Application ref: 25/1020/OUT
Location: Land East Of Oxhey Lane, Oxhey Lane, Carpenders Park, Hertfordshire
Proposal/Description: Outline planning application for up to 256 homes (C3 use class) (including affordable and self/custom build housing), housing with care (C2 use class), a children's home (for looked after children) (C2 use class) together with associated access (including off-site highway works), parking, open space and landscaping (appearance, layout, landscaping and scale as reserved matters.)

This letter is in response of the recently submitted documents 13 Jan 2026.

1.0. LVIA Addendum

Visual context

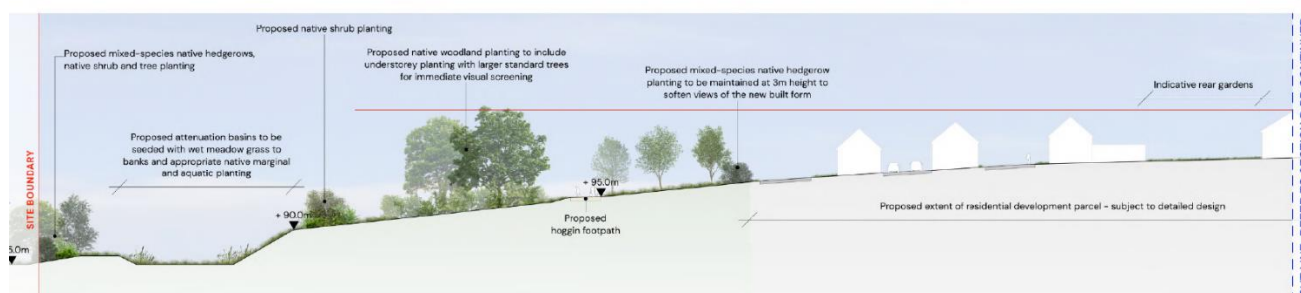
The relationship between the site and the built edge of settlement is not questioned. But we consider that the site also has a visual connection with the rural landscape with views to the south from the mid and southern site parcels, although we acknowledge these are not publicly accessible locations. The LVIA has recognised open views to the west and panoramic views southeast.
